February 19, 2003  
1424-9C

**RE: HEALTH RISK APPRAISAL AND  
RESPONSE TO TECHNICAL  
COMMENTS  
1300 POWELL STREET  
EMERYVILLE, CALIFORNIA**

This report responds to your February 14, 2003 letter, which included technical comments for 1300 Powell Street located in Emeryville, California (Site).

**FIGURE 1**  
 1424-9C

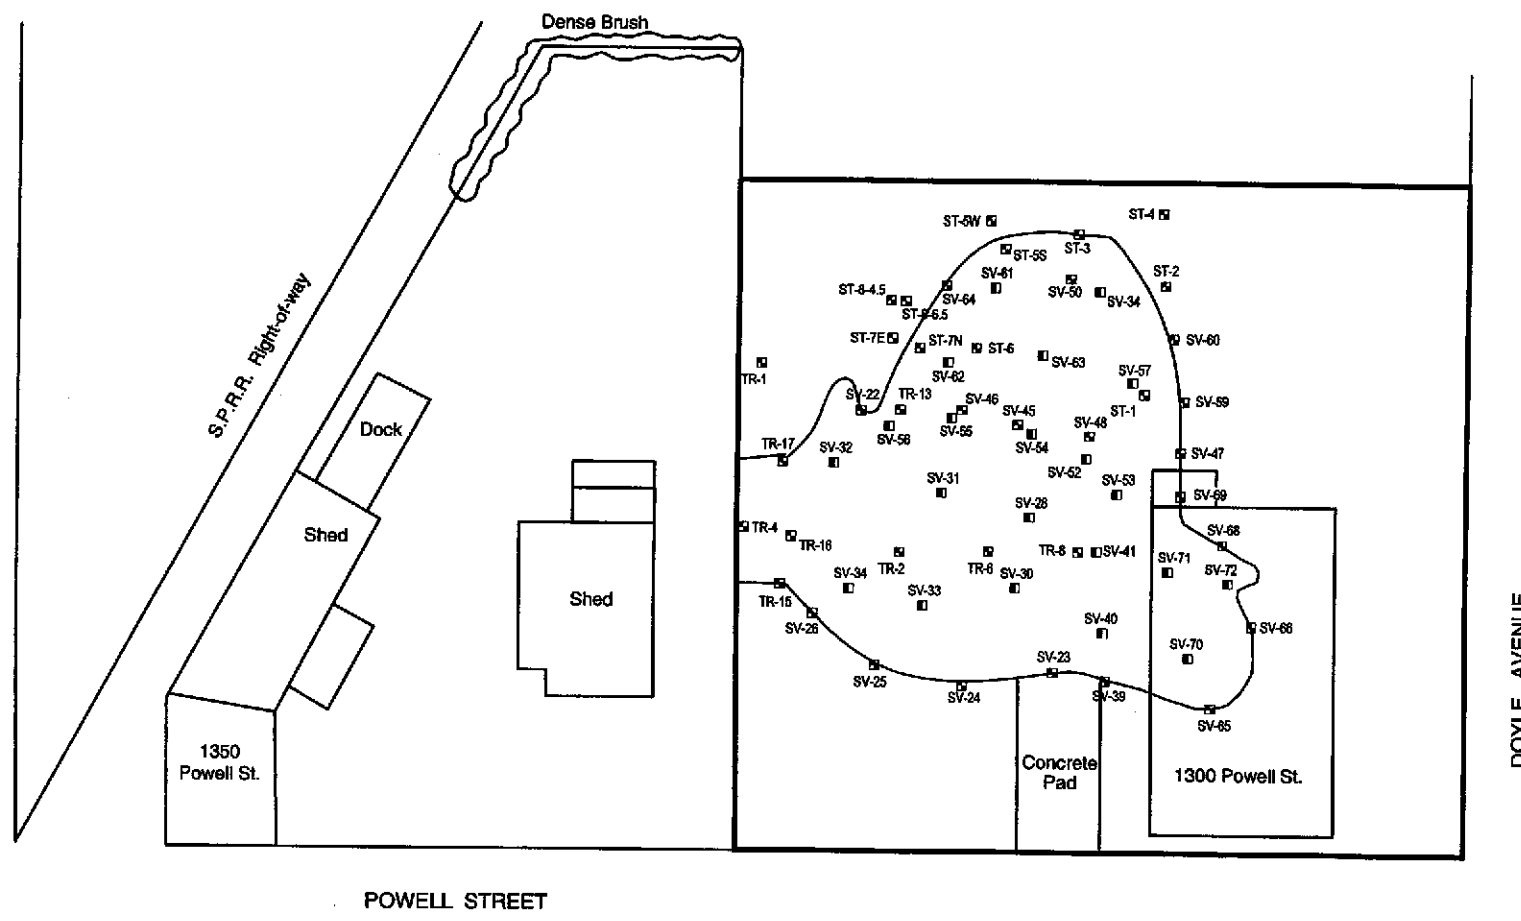
This report has been prepared to respond to a letter from Alameda County Environmental Health (ACEH) dated February 14, 2003, which requested technical comments for 1300 Powell Street located in Emeryville, California (Site). The following items were requested: 1) a risk assessment for residual contaminants detected at the site, 2) address the elements in the ACEH letter dated June 21, 2002, and 3) prepare an updated site plan to include the location of soil samples SV-45, SV-46, SV-48, SV-50, and samples with the ST- and TR- numbered samples. The elements in the June 21, 2002 letter include: 1) placement of clean imported soil in the upper 2 feet of soil in all landscaped areas, planting boxes, etc., 2) vapor barriers under all inhabited structures with no utility penetration of the vapor barriers, 3) final site development plans submitted prior to site development, 4) post-remedial ground water monitoring to confirm concentrations of residual ground water contaminants, and 5) deed notifications/restrictions. The responses to items 1 and 2 of the February 14, 2002 letter are addressed below. Item 3 (revised figure) is included as Appendix A.

According to the CRWQCB's East Bay Basin Plan the ground water in Emeryville is not considered a drinking water source. Therefore, the applicable RBSLs for TPHd and TPHmo are 500ppm and 1000 ppm, respectively (Table B, RBSL Document). Only one location (TR-17, 820 ppm) exceeded the non-drinking water resource RBSLs. Further after completion of remedial excavation activities, approximately 40 cubic yards of additional soil were removed from the area of TR-17 for geotechnical purposes and disposed off-site. The additional soil was removed to within approximately 10 feet of sample TR-1. As discussed above, none of the final verification soil samples exceeded the approved cleanup goals.
